CCES
Responses

FLYING HORSE NORTH FILING NO. 1
GRADING AND EROSION CONTROL PLAN

FLYING HORSE NORTH FILING NO. 1
COUNTY OF EL PASO, STATE OF COLORADO
GRADING AND EROSION CONTROL PLAN
DECEMBER 2017

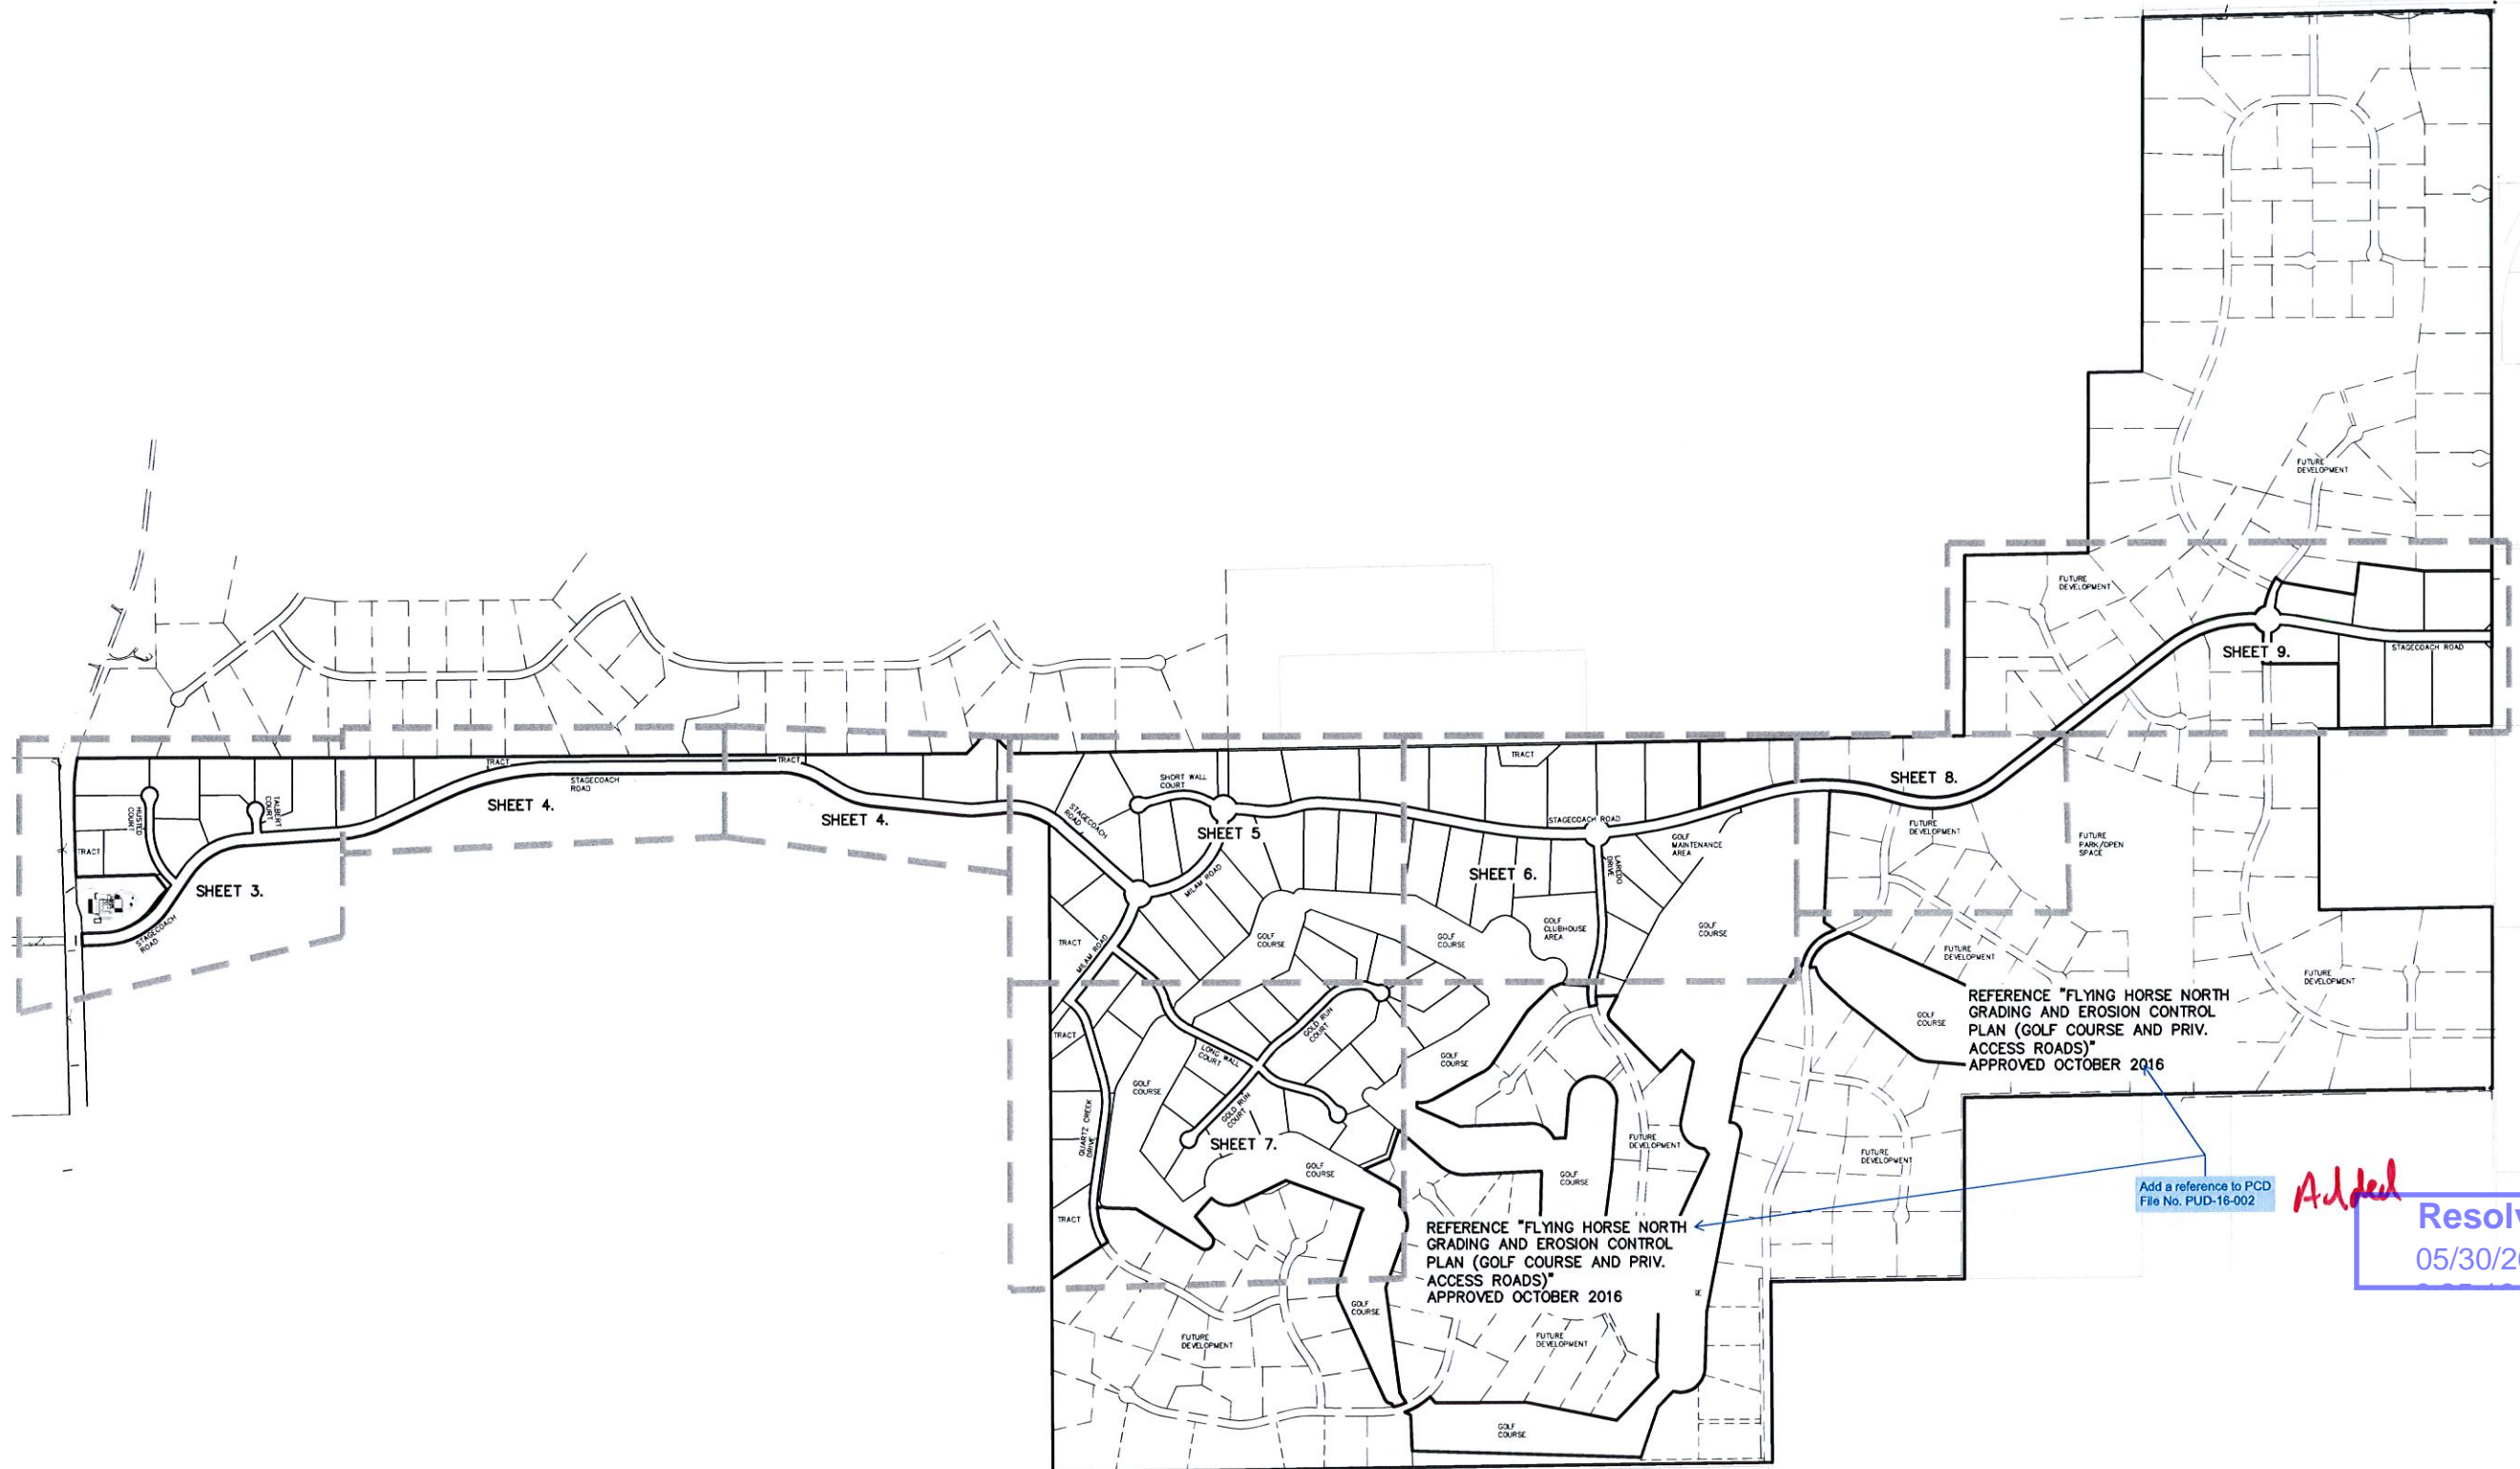
Fill in the blank

Add PCD File No. SF-18-001

Resolved
05/30/2018

FLYING HORSE NORTH FILING NO. 1 GRADING AND EROSION CONTROL PLAN			
DESIGNED BY	MAW	SCALE	DATE 12/12/17
DRAWN BY	MAW	(H) 1" = 100'	SHEET 5 OF 10
CHECKED BY		(V) 1" = N/A	JOB NO. 1096.11

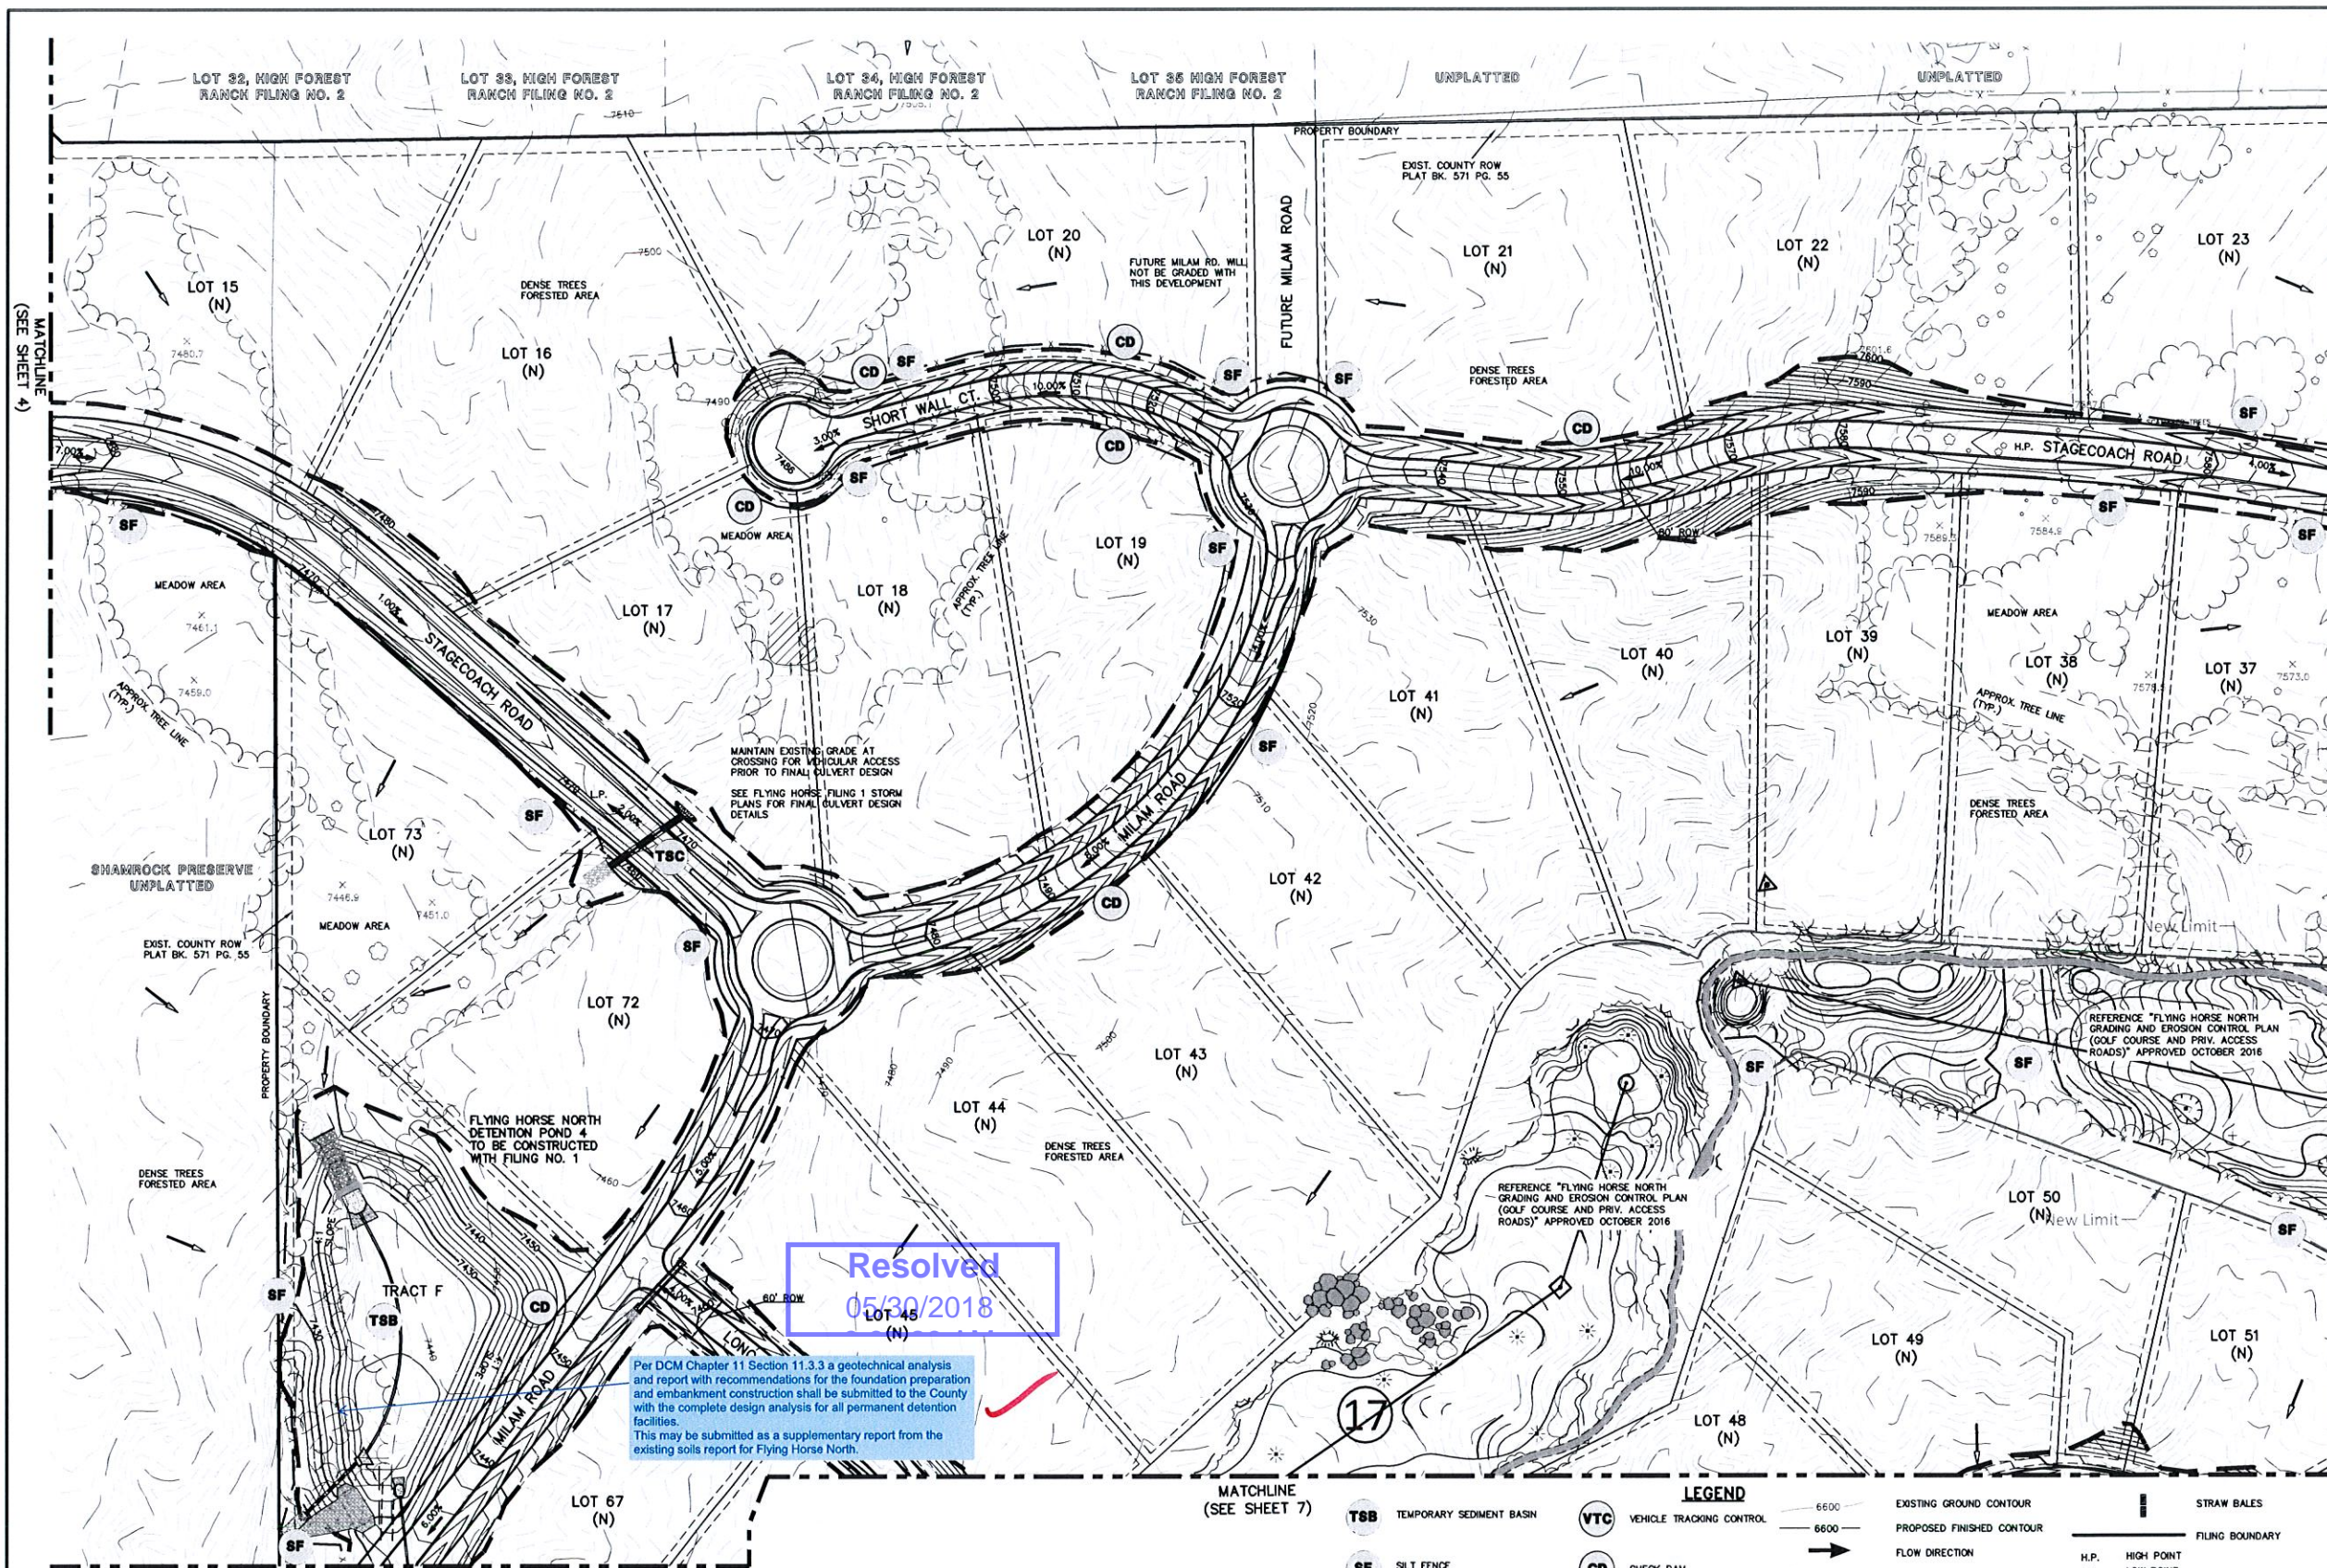
Per DCM Chapter 11 Section 11.3.3 a geotechnical analysis and report with recommendations for the foundation preparation and embankment construction shall be submitted to the County with the complete design analysis for all permanent detention facilities.
This may be submitted as a supplementary report from the existing soils report for Flying Horse North.

Resolved
05/30/2018

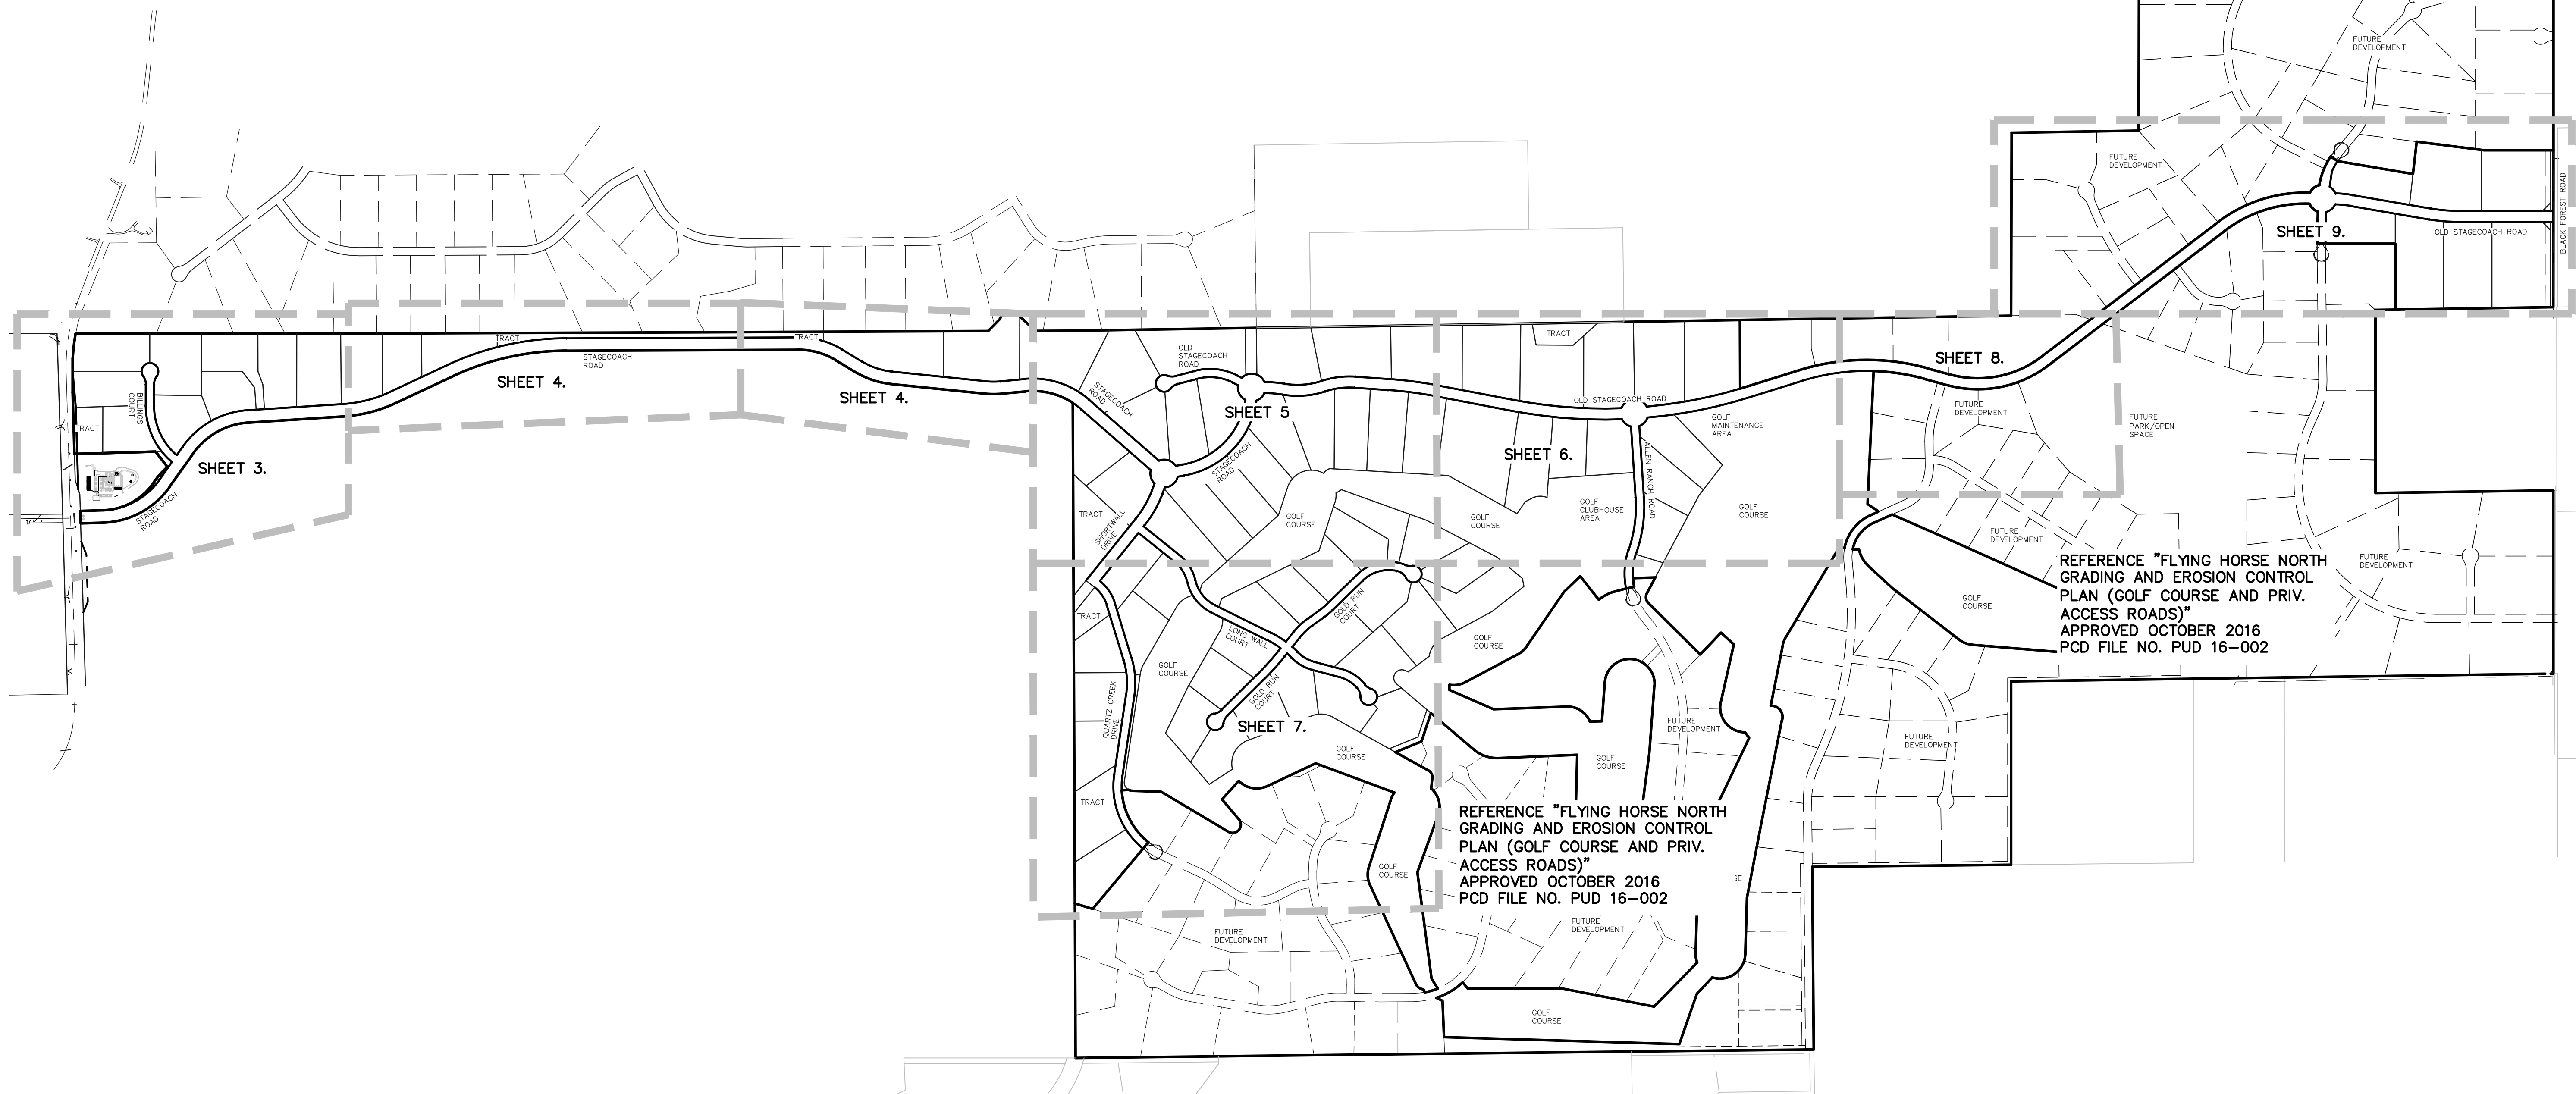
A geotechnical analysis and report with recommendations for the foundation preparation and embankment construction shall be submitted with the complete design analysis for all permanent detention facilities.

Entech providing separate report for ponds

Currently working on east plans.
